MANDATORY SERVICE BULLETIN

Service Bulletin No. 525A
(Supersedes Service Bulletin No. 525)
Engineering Aspects are
FAA Approved

SUBJECT: Inspection of High Pressure Fuel Pump P/N LW-15473

Figure 1.

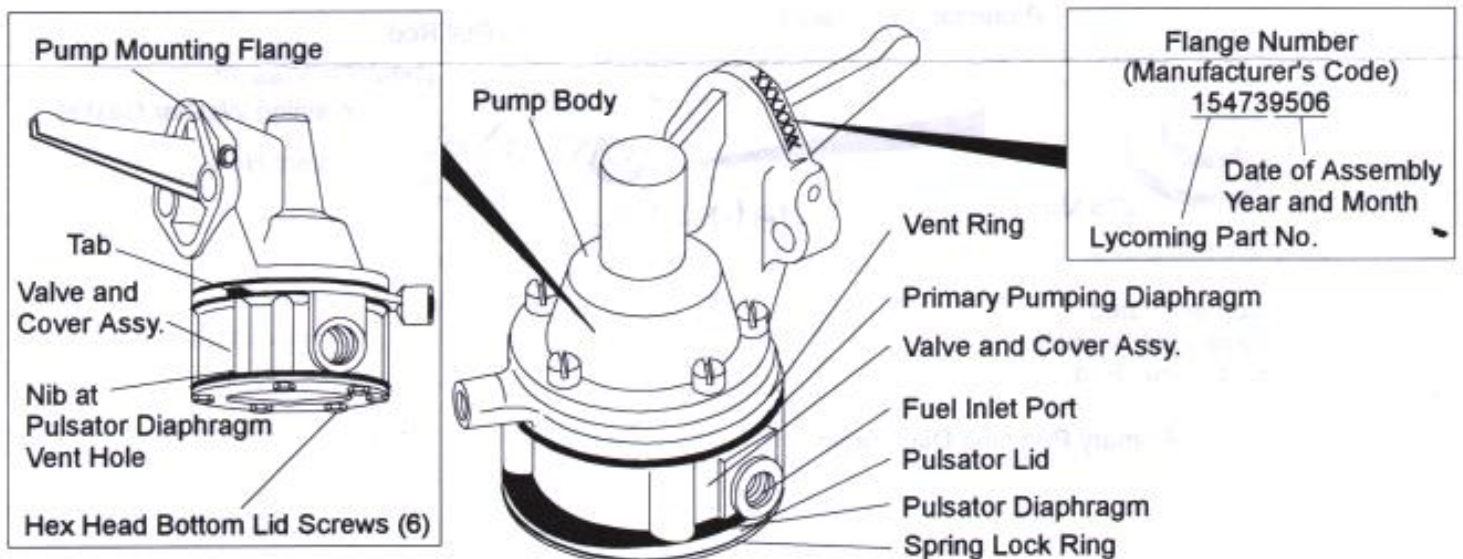
If your Textron Lycoming engine has a P/N LW-15473 high pressure fuel pump installed, with flange number (manufacturer's code) scribed on the pump of 154739506, 154739507 or 154739510, it must be inspected before further flight of your aircraft.

3. Completely loosen but do not remove the six hex head bottom lid screws and remove the entire bottom section of the pump as a unit assembly including the lid screws and valve and cover assembly. (Refer to Figure 1 and 4.) Set this unit assembly aside for later examination (step 7). Note, this unit may be further disassembled for cleaning.

11. To identify that this examination was accomplished on the pump assembly, mark an "A" by metal stamp or scribe on the pump mounting flange immediately before the flange number (manufacturer's code). (Refer to Figure 1). If necessary due to space constraints, the "A" may be located just above the rocker shaft pin. An entry in the engine and/or aircraft log book should also be made.

Figure 2.

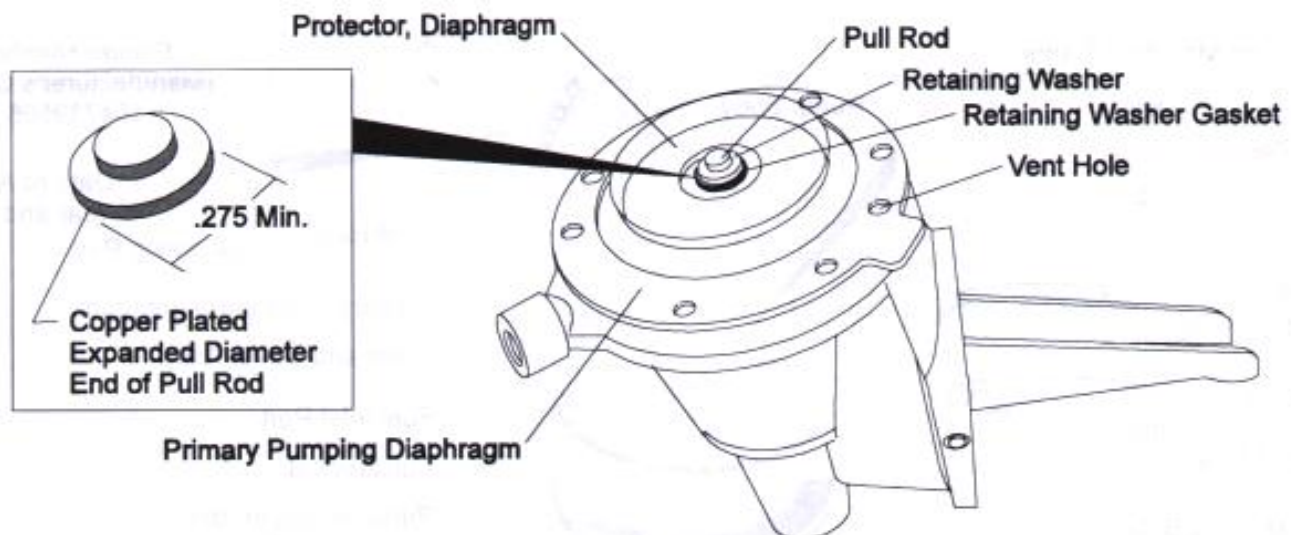
4. Visually inspect for proper location and retention of the retaining washer gasket in the pull rod/diaphragm assembly. (Refer to Figure 2.) If the gasket is not found between the retaining washer and diaphragm protector or it protrudes more than 1/16 inch beyond the retaining washer at any point, the pump is unserviceable and must be replaced.

5. Using vernier or dial calipers, measure the diameter of the larger copper plated expanded end of the pull rod immediately next to the retaining washer (see Figure 2). If this diameter measures less than .275 inches, the pump is unserviceable and must be replaced.

Figure 3.

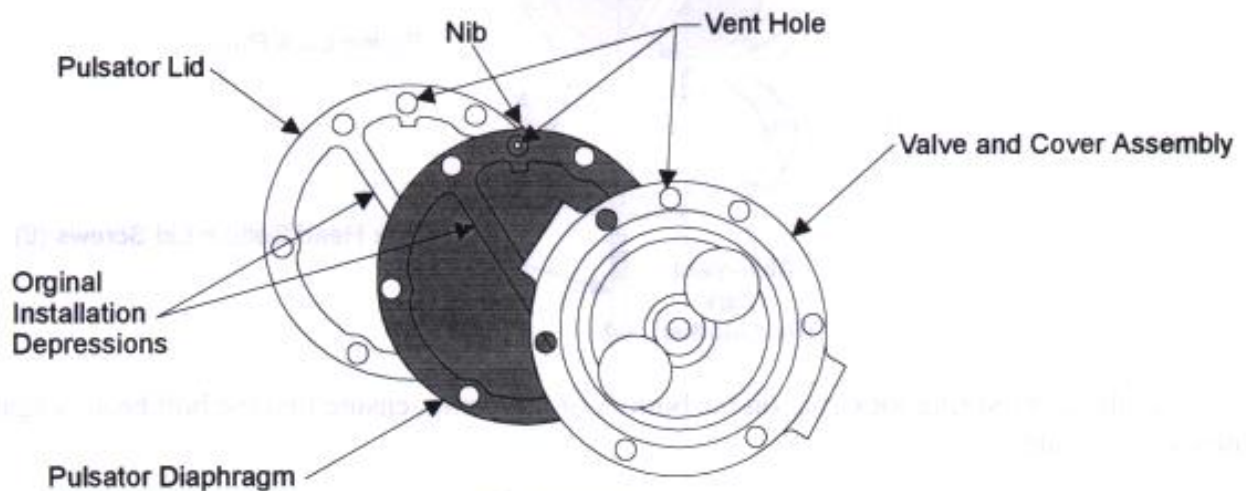
8. Place the pulsator diaphragm over the pulsator lid, aligning the pulsator diaphragm vent hole (small hole near the diaphragm periphery) with the vent hole in pulsator lid. (Refer to Figure 3.)

INSTALL PULSATOR DIAPHRAGM SO THAT THE SAME SIDES (ORIGINAL INSTALLATION DEPRESSIONS) ARE ALIGNED WITH THE DIVIDER IN THE PULSATOR LID.

9. Place the valve and cover assembly on the diaphragm, aligning its vent passage with the pulsator diaphragm and pulsator lid vent holes. (Refer to Figure 3.)

Figure 4.

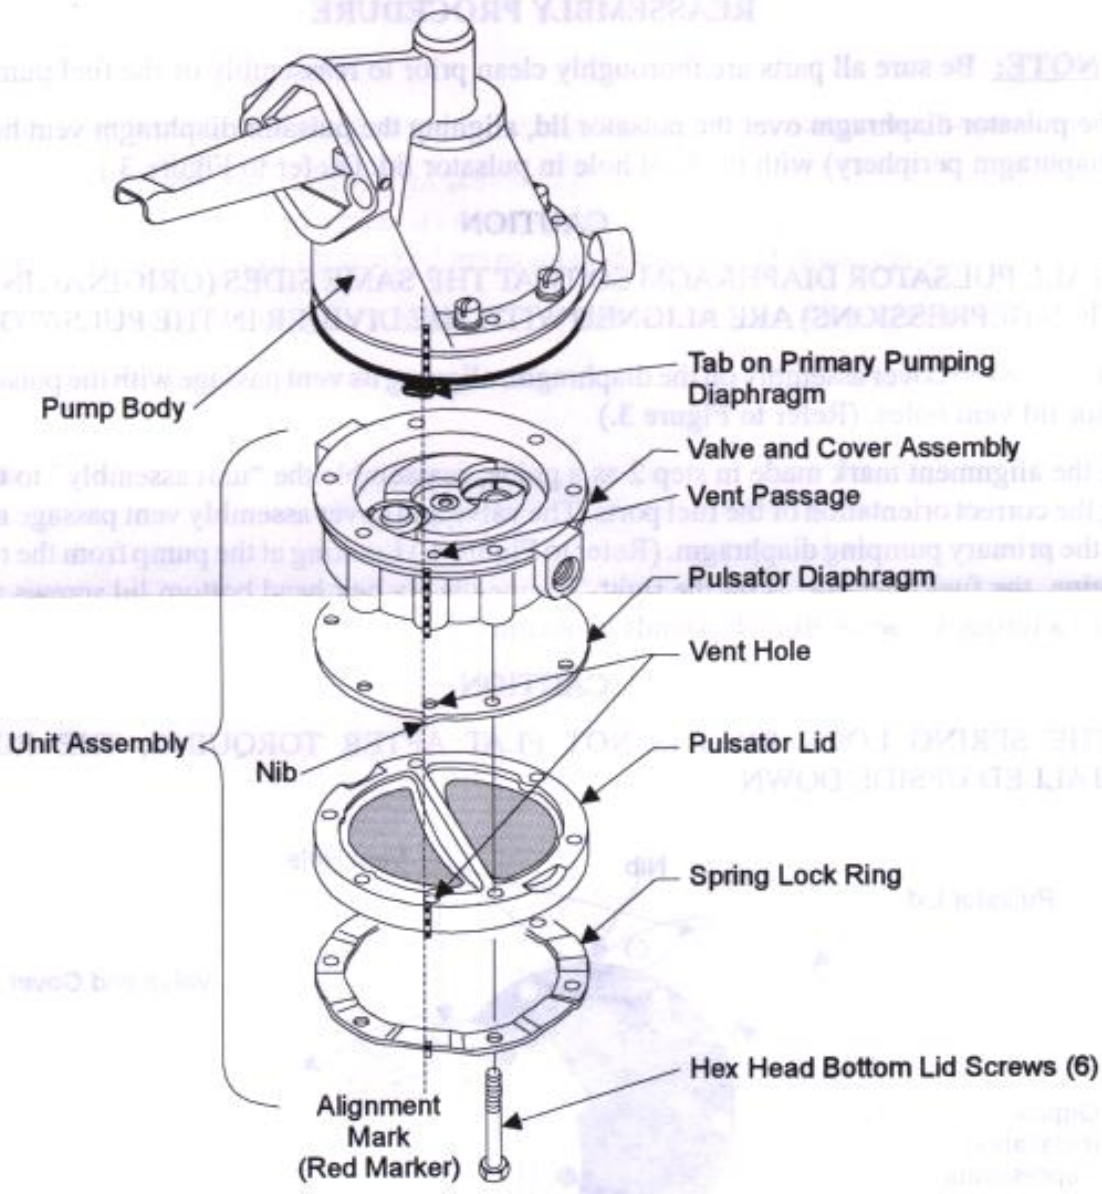
2. With a red permanent ink felt tip marker, make an alignment mark down the side of the pump assembly at the vent passage boss (Refer to Figure 4) to aid in part alignment for subsequent reassembly. Ensure all parts (including diaphragm) are marked for reassembly.

7. Examine the pulsator diaphragm from the unit assembly set aside in step 3, (Refer to Figure 4) as follows:

10. Using the alignment mark made in step 2 as a guide, reassemble the "unit assembly" to the pump body observing the correct orientation of the fuel ports. The valve and cover assembly vent passage must align with the tab on the primary pumping diaphragm. (Refer to Figure 4.) Looking at the pump from the rear as installed on the engine, the fuel inlet port is on the right. Torque the six hex head bottom lid screws alternately and evenly until a torque value of 30 inch pounds is obtained.

When reinstalling the spring lock ring on the bottom of the pump, ensure that the bolt head is against the high segments of the ring.

IF THE SPRING LOCK RING IS NOT FLAT AFTER TORQUING, THE RING IS INSTALLED UPSIDE DOWN.
